ADDENDUM NO. 2

DATE OF ISSUANCE: March 21, 2023

PROJECT: 2023 Henryville Flooring Replacement
Phase 2 & Cafeteria Expansion
213 N. Ferguson. St.
Henryville, IN 47126

ARCHITECT'S PROJECT NO.: 21-47.007

SHEET NUMBER
S201
2021.47.007

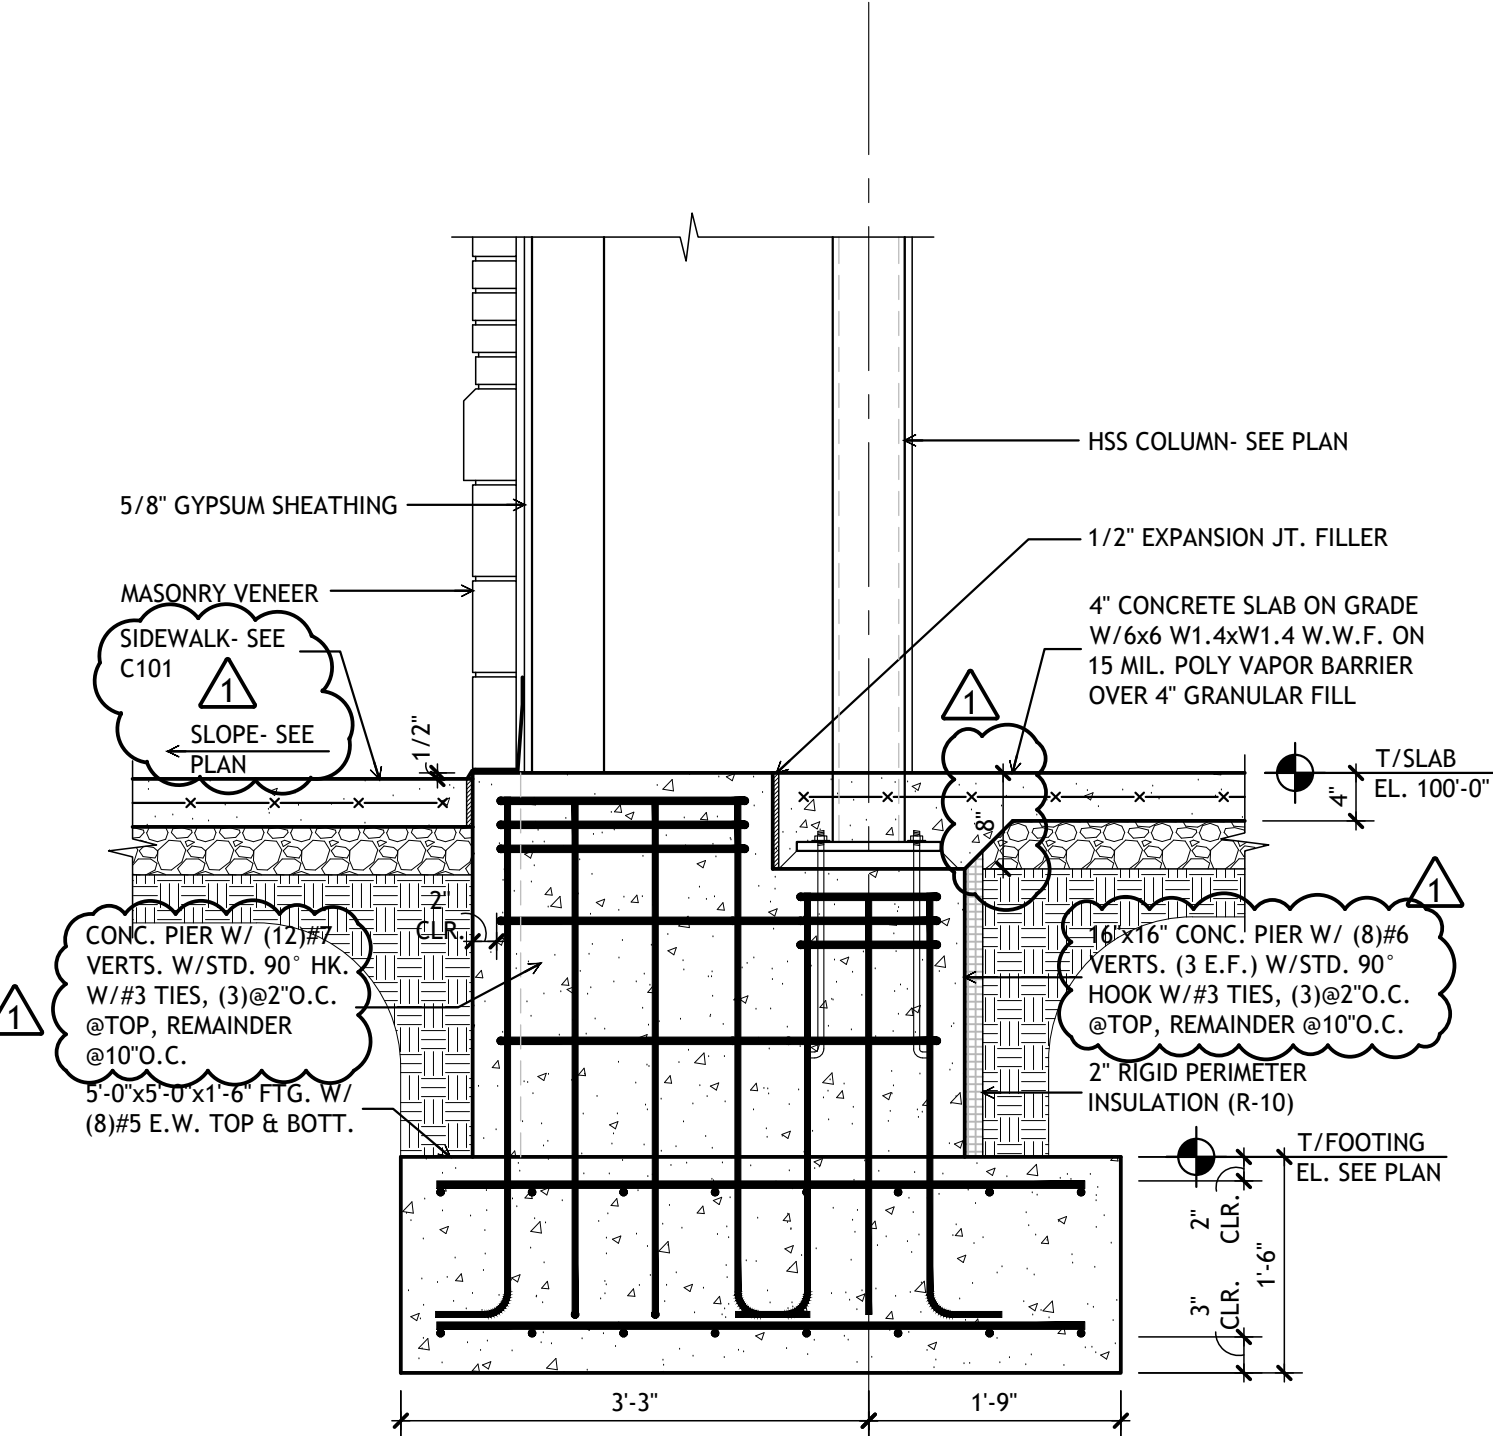
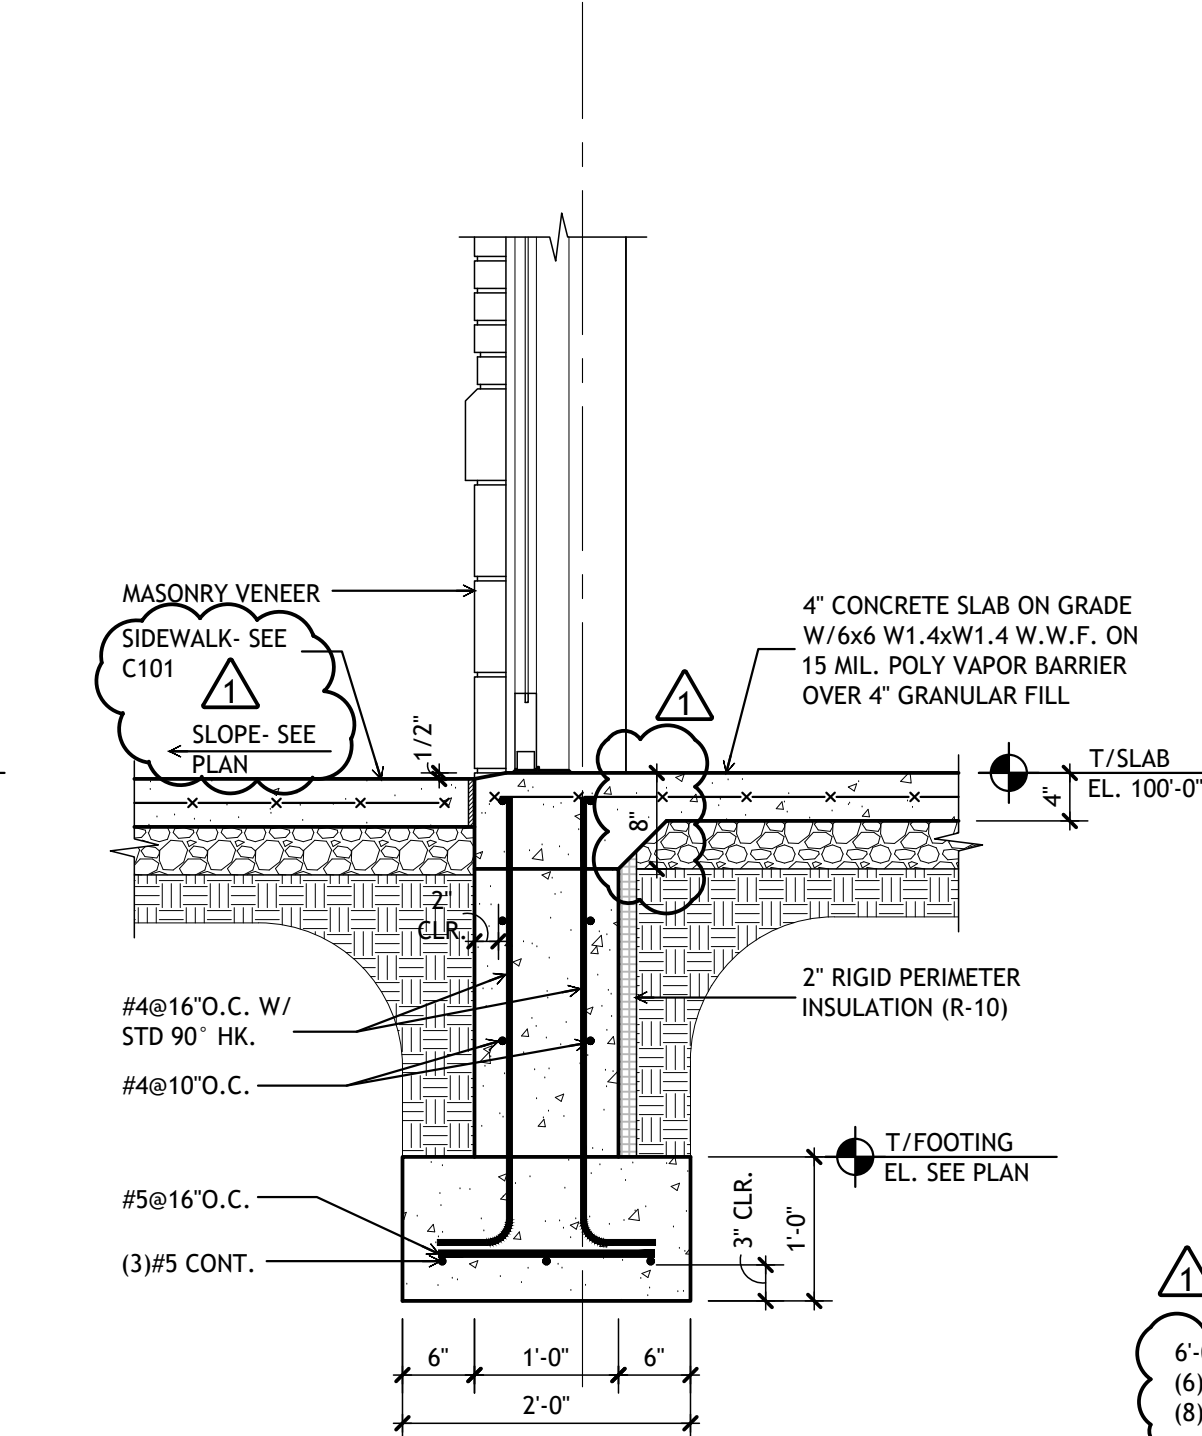
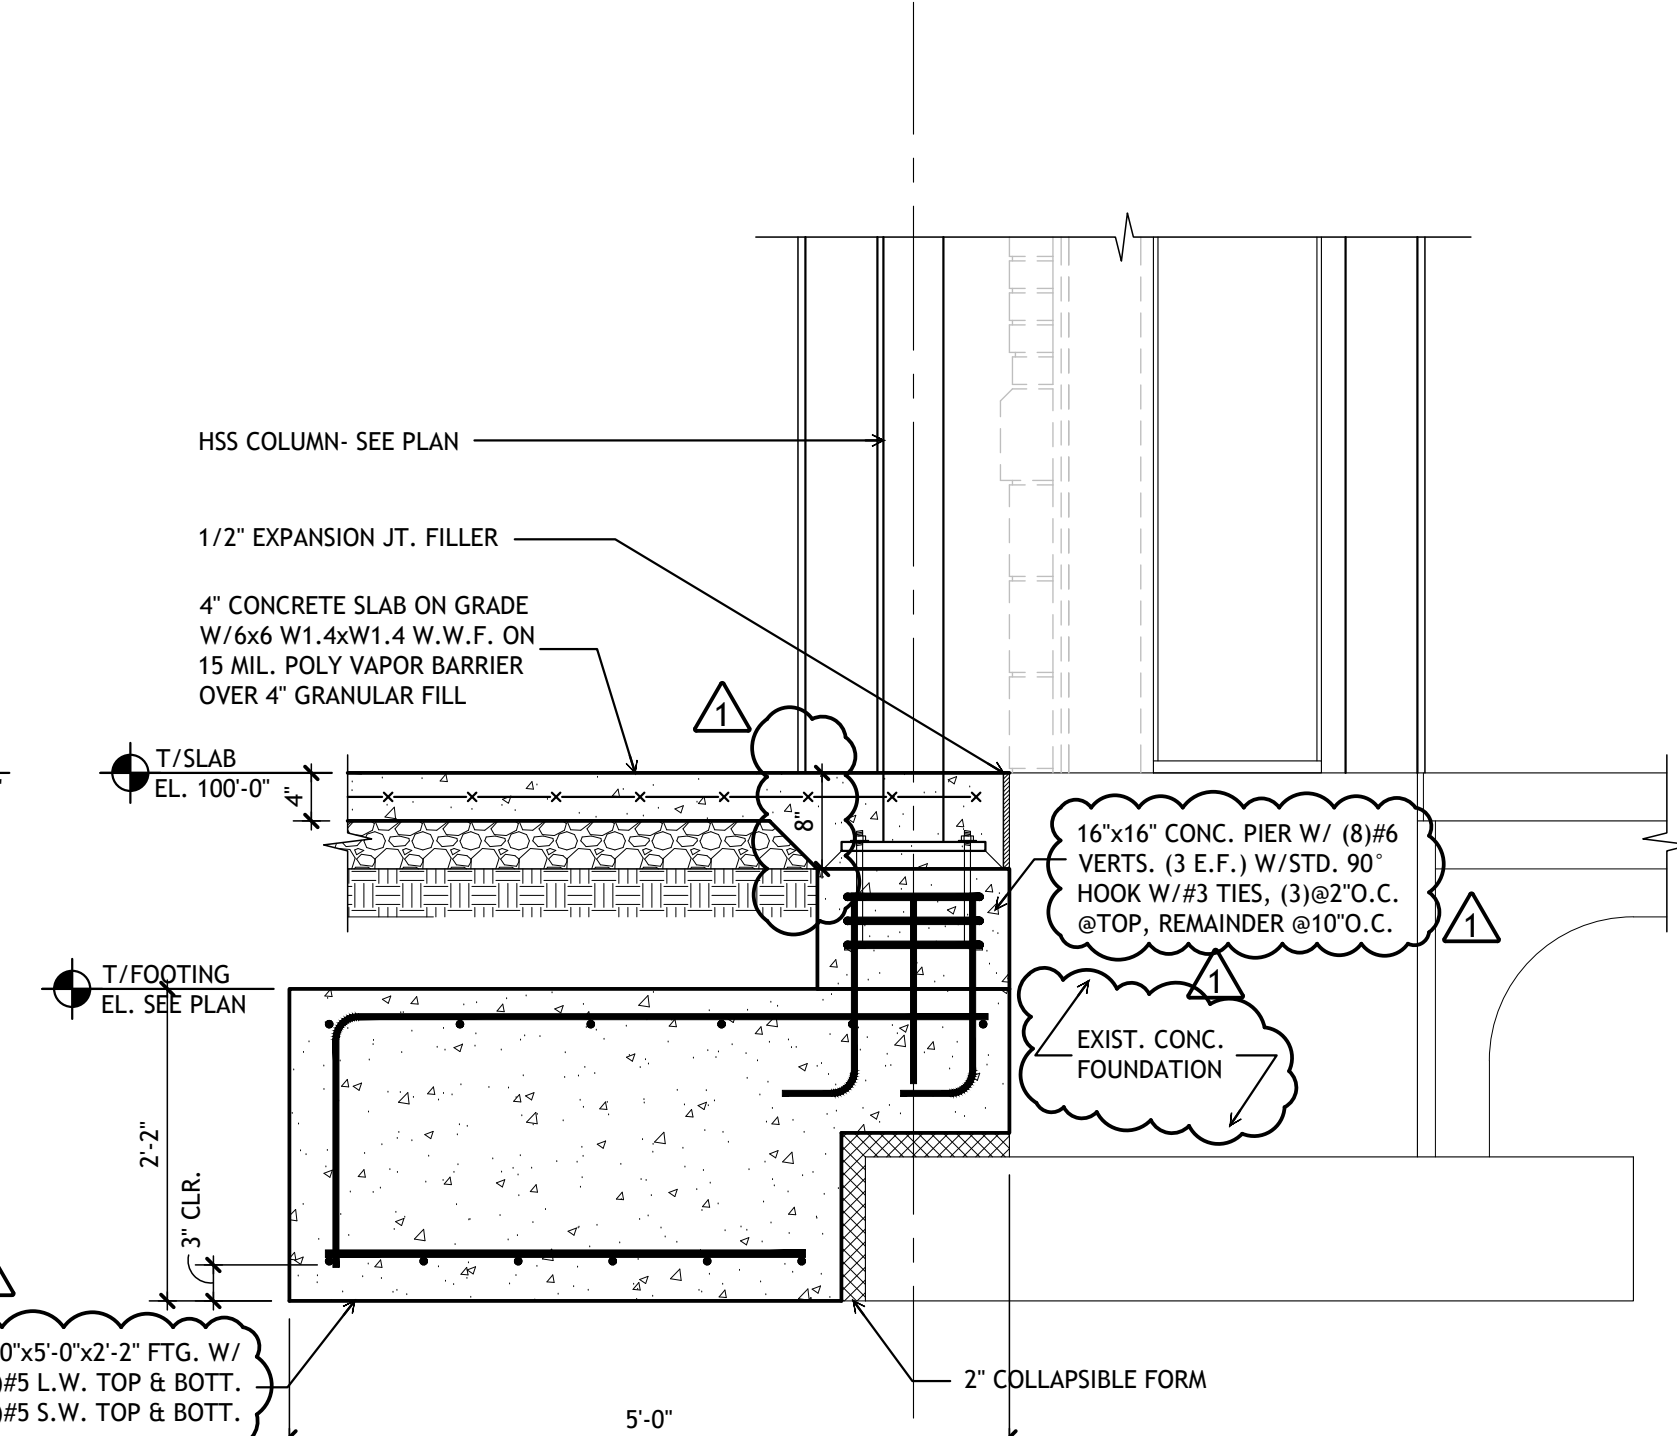
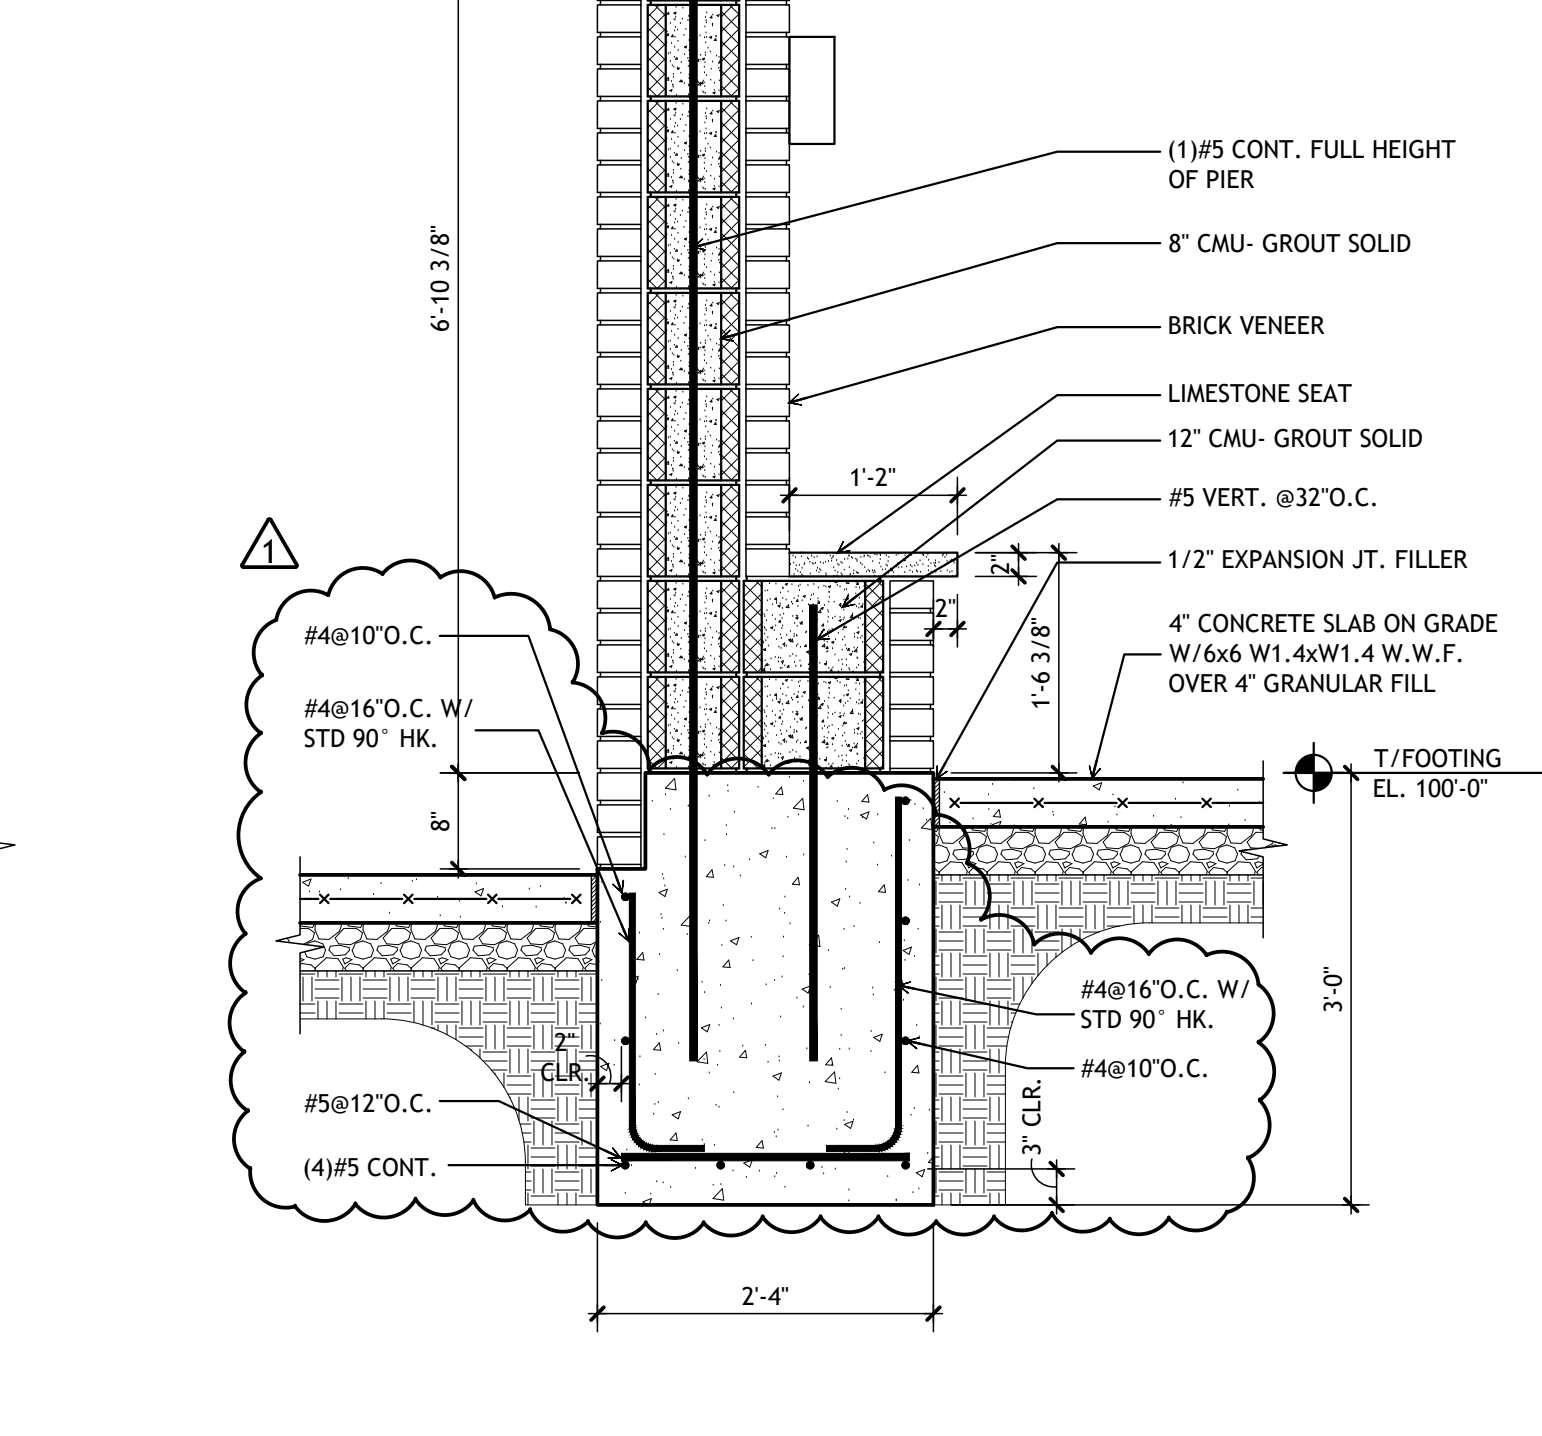
ADD-1 Item No. D-5 - Foundation Details

Refer to Sheet(s): S201 and S202

Replace with attached revised Drawings in their entirety; revisions have been clouded for reference.
